## **MONITORING YEAR 3 ANNUAL REPORT**

### **OWL'S DEN MITIGATION SITE**

Lincoln County, NC  
DEQ Contract 005150  
DMS Project Number 95808

RE: Owl's Den Mitigation Site-Year 3 Monitoring Report  
Final Submittal for DMS  
Contract Number 004673, RFP Number 16-004110, DMS# 95360  
Yadkin River Basin – CU# 03040105; Union County, NC

Figure 3.0 Integrated Current Condition Plan View (Key)  
 Owl's Den Mitigation Site  
 DMS Project No. 95808  
 Monitoring Year 3- 2018  
 Lincoln County, NC

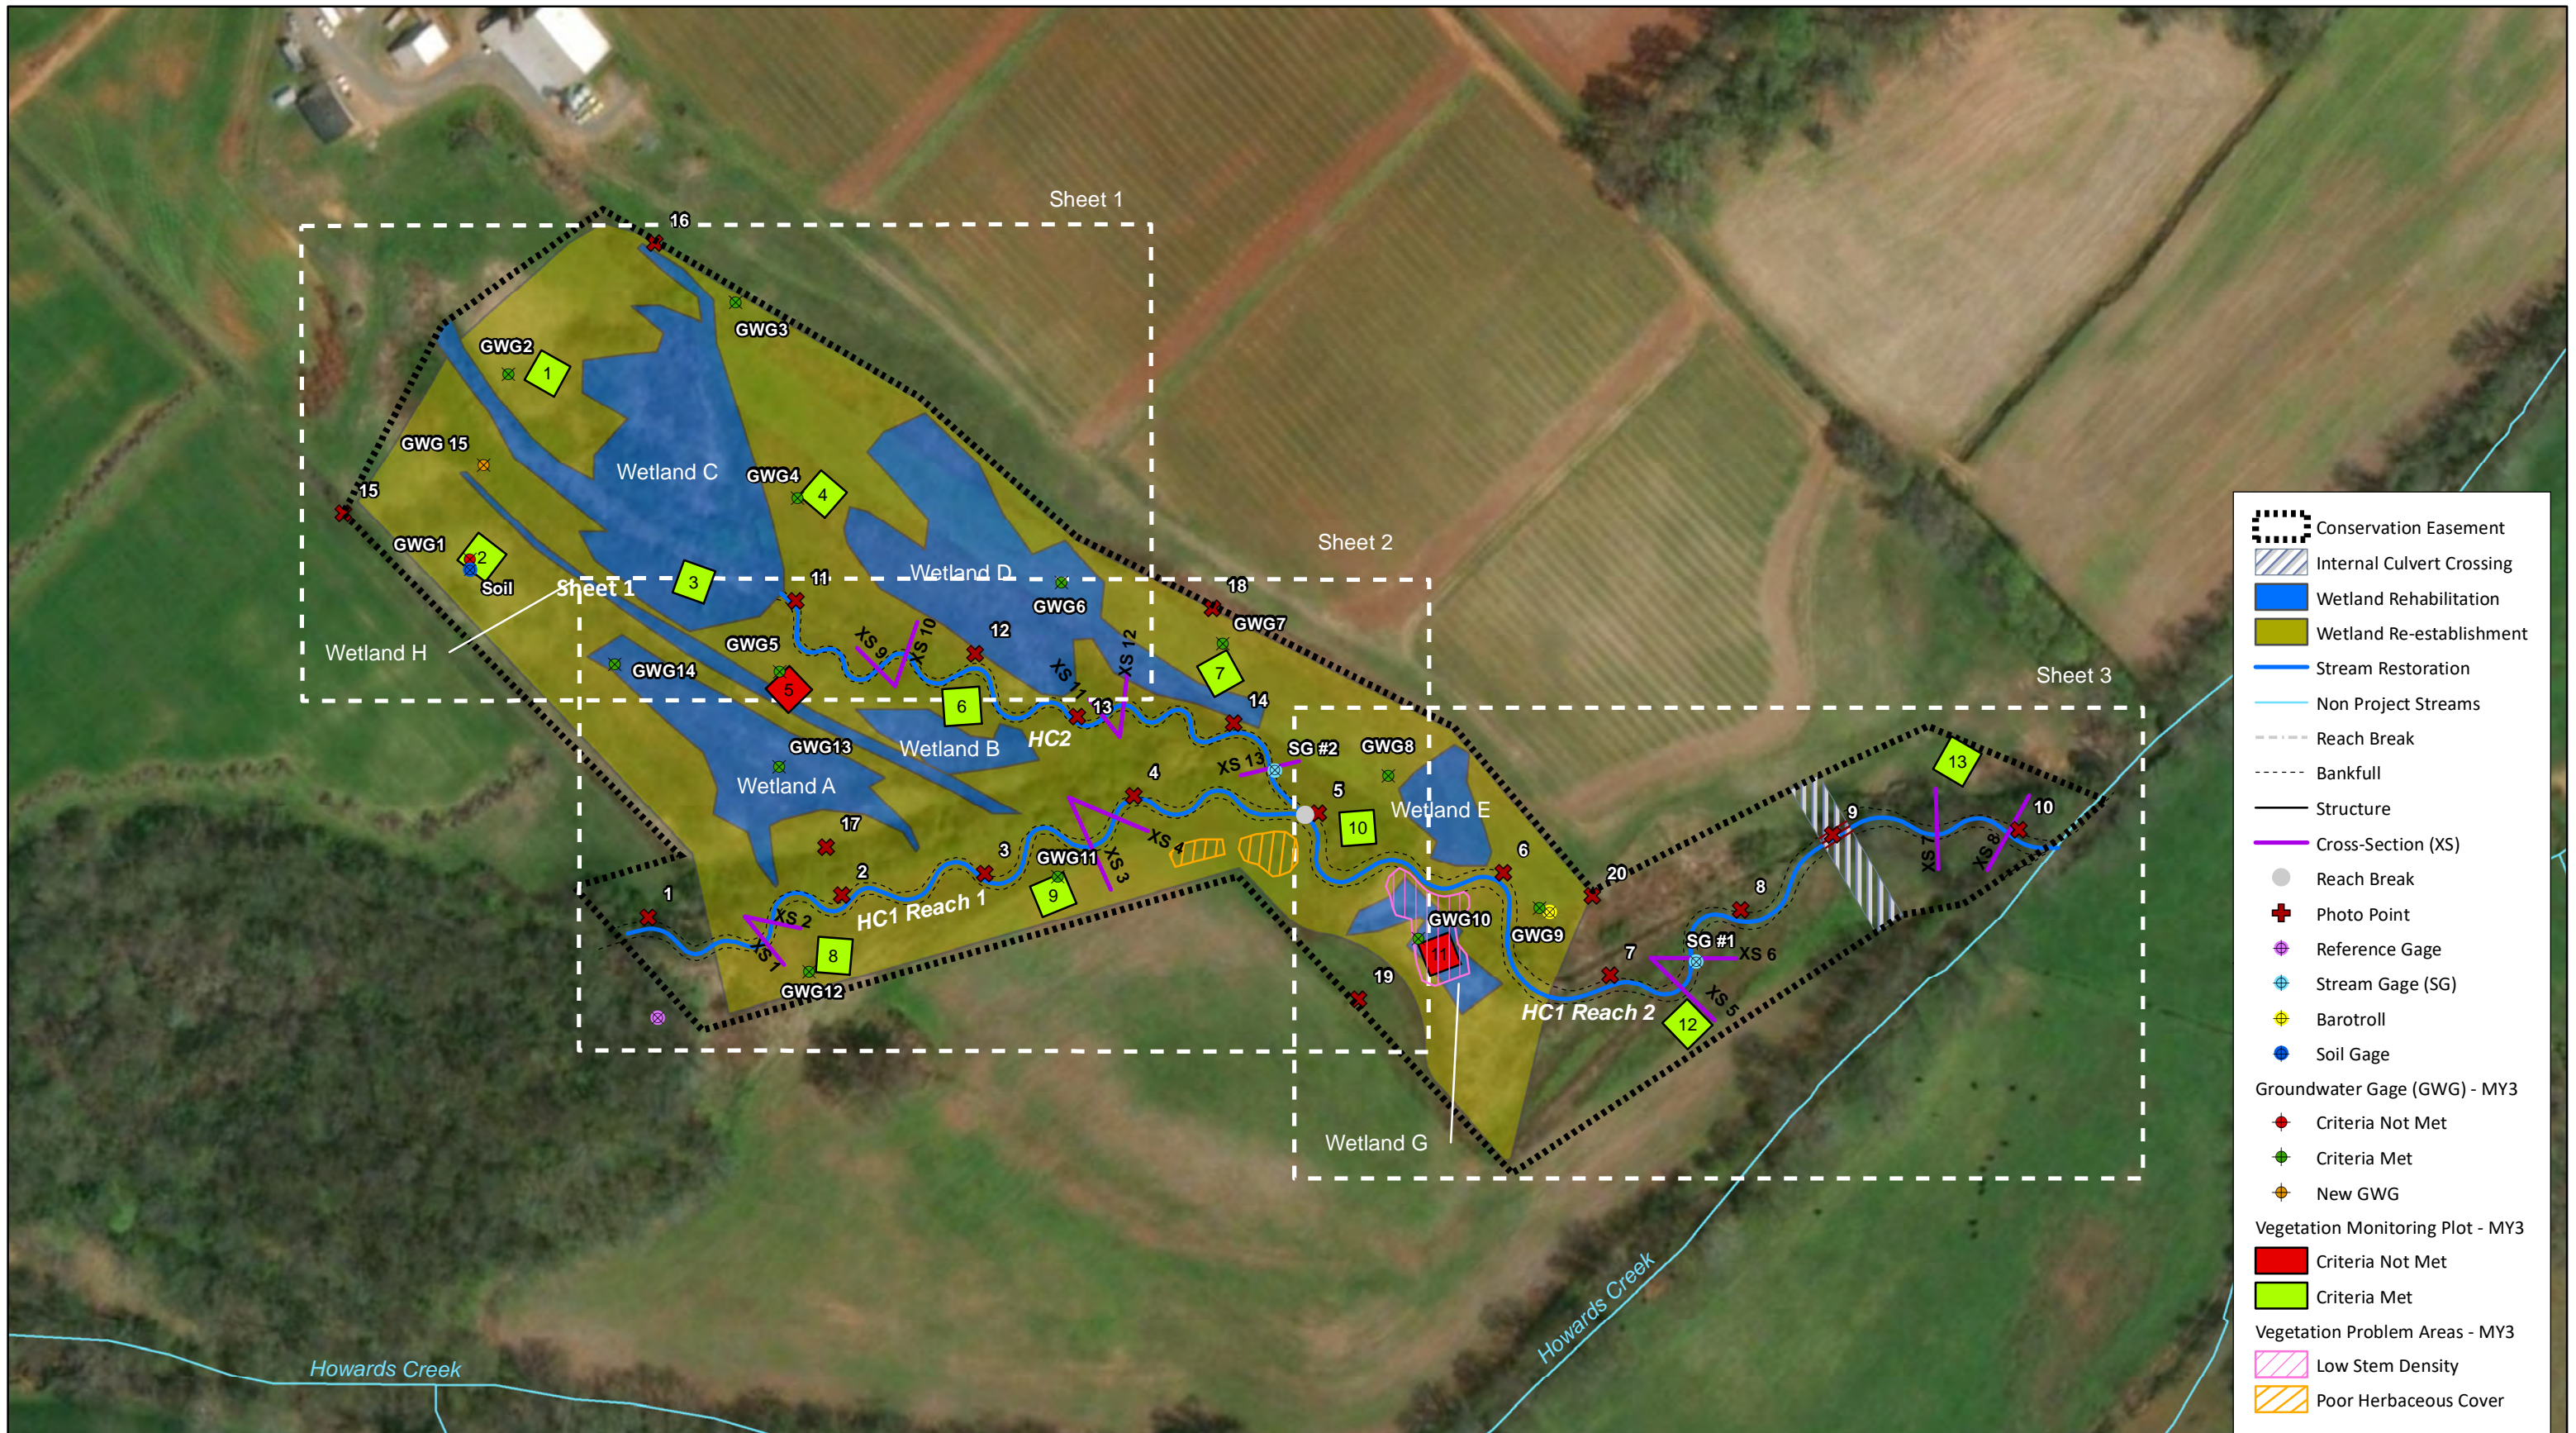
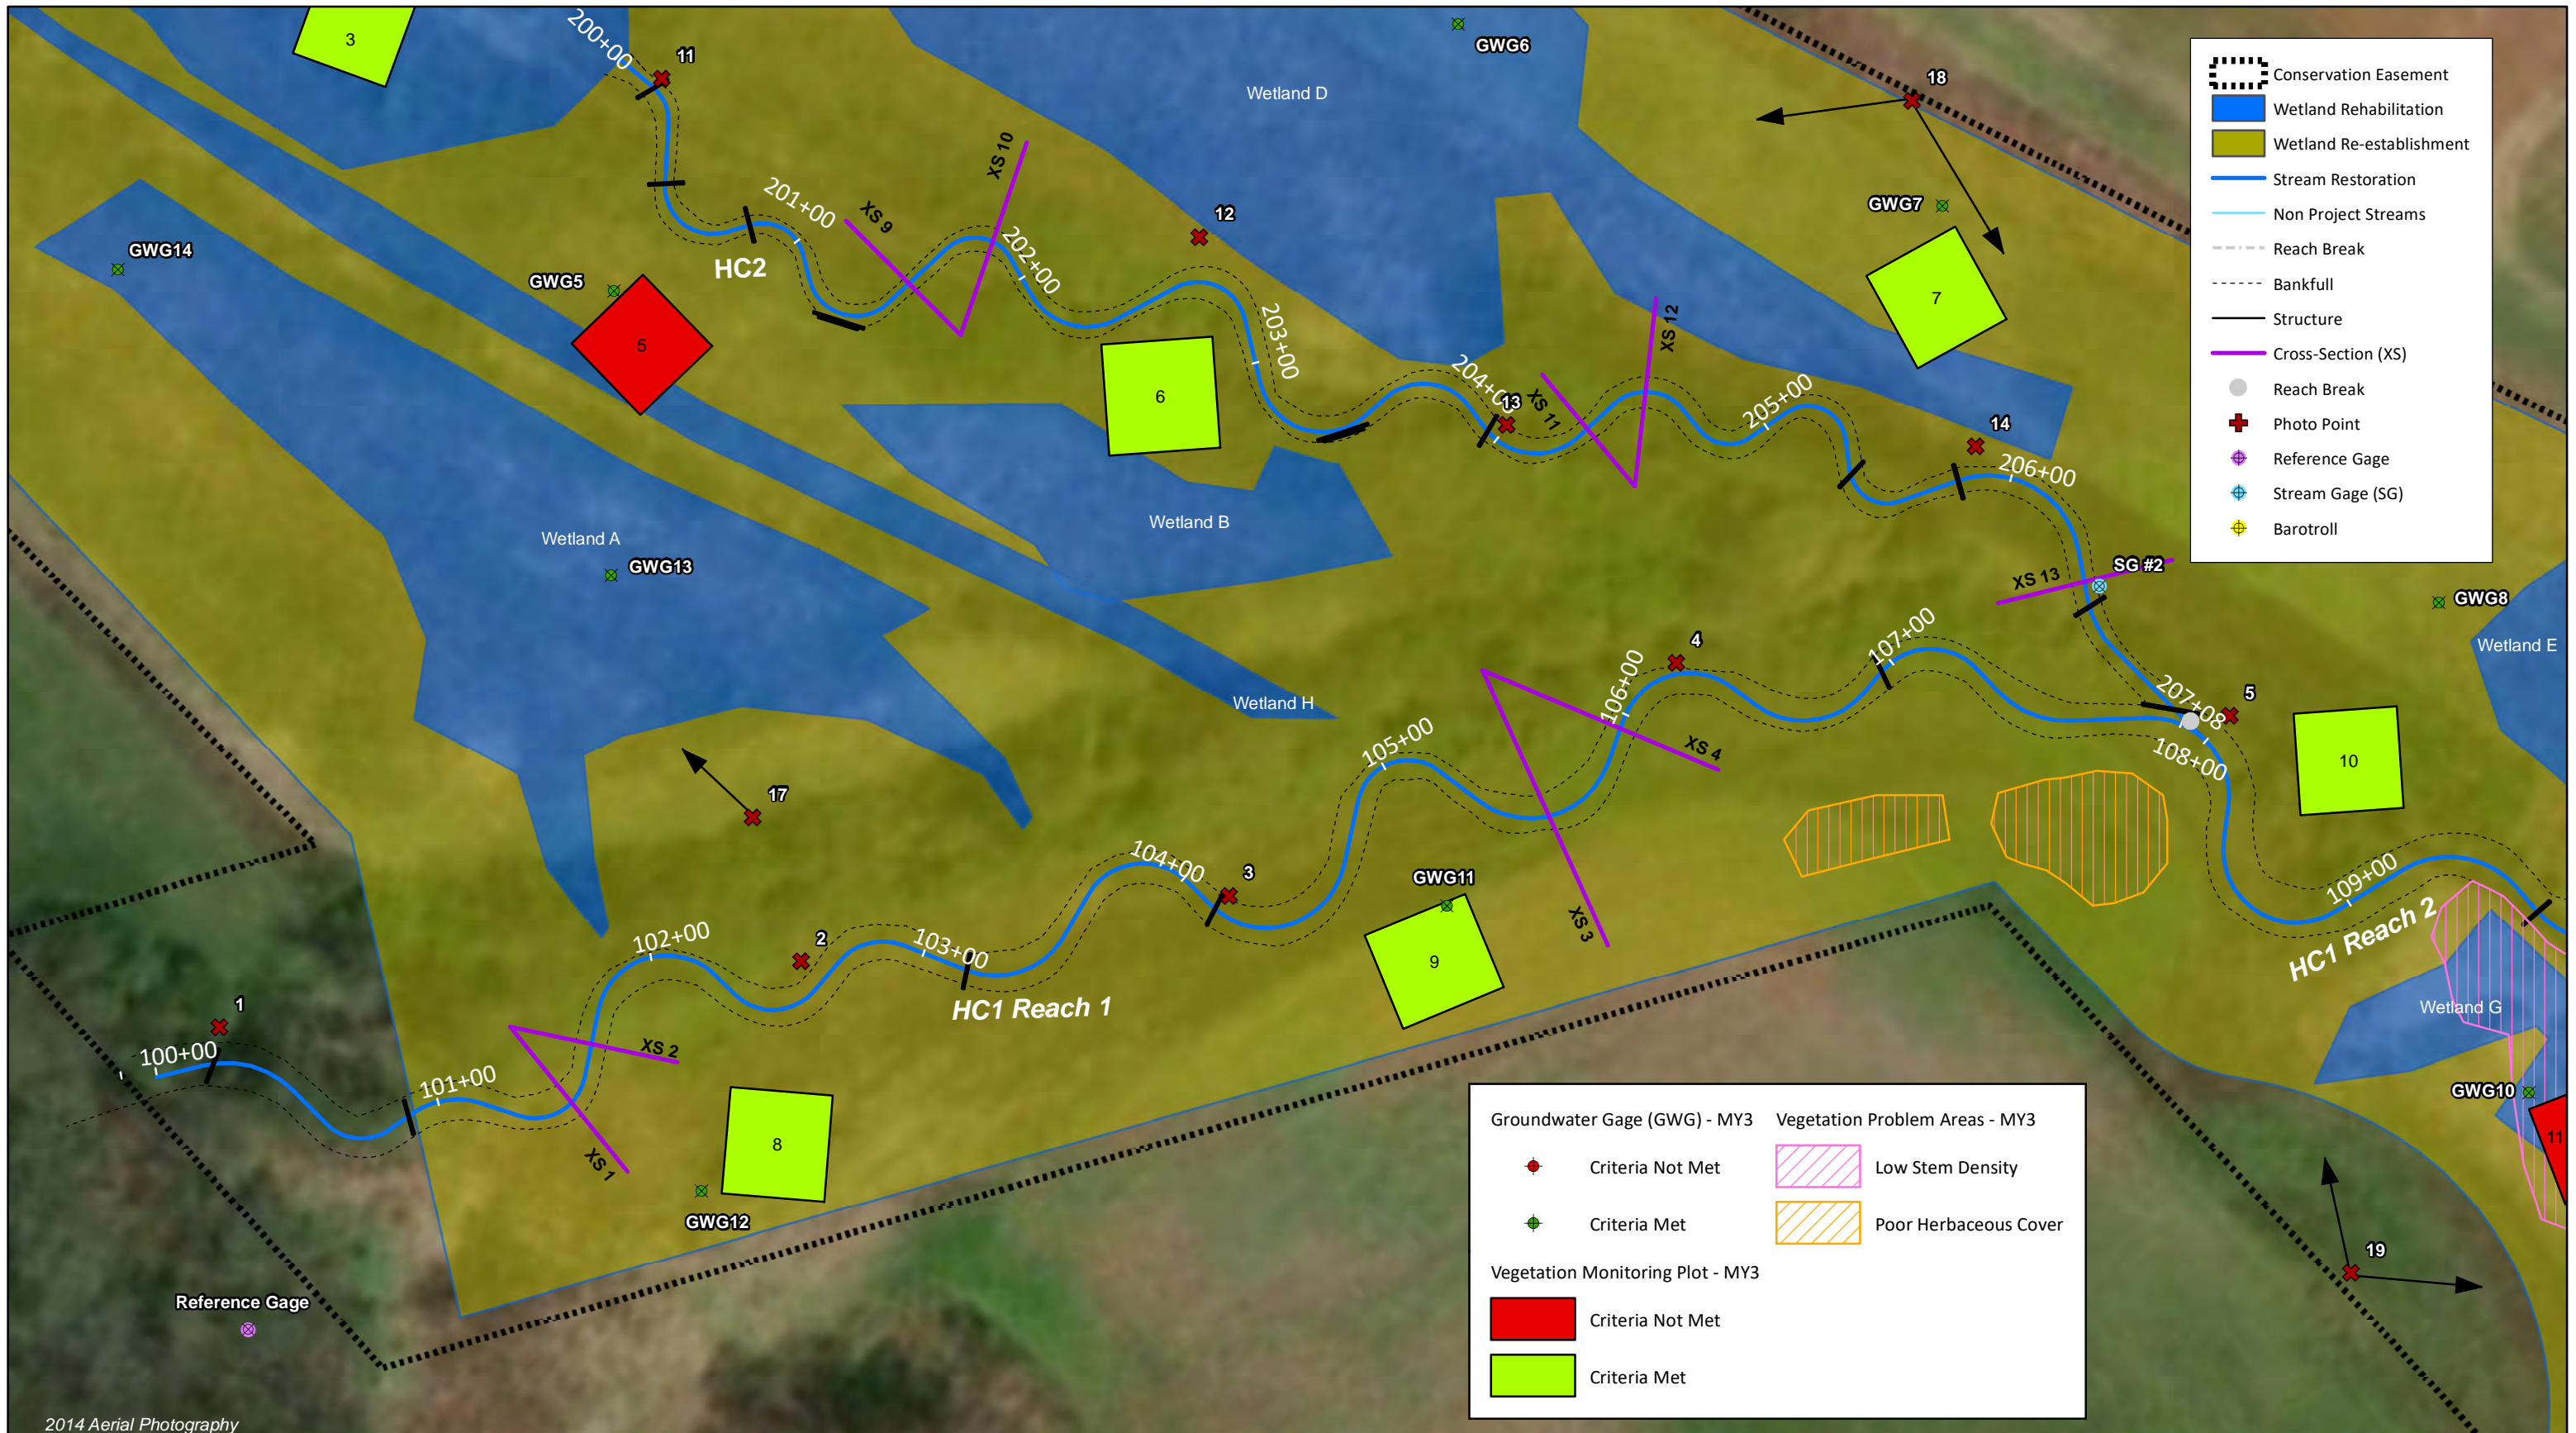
**DMS Comment; General: The report text indicates that an additional groundwater gage and a soil temperature probe will be installed and monitored in MY4. Please show the proposed locations of the additional MY4-MY7 monitoring equipment on the CCPV sheets.**

*Wildlands Response; The CCPV sheets have been updated to reflect the additional groundwater and soil temperature probe proposed locations.*
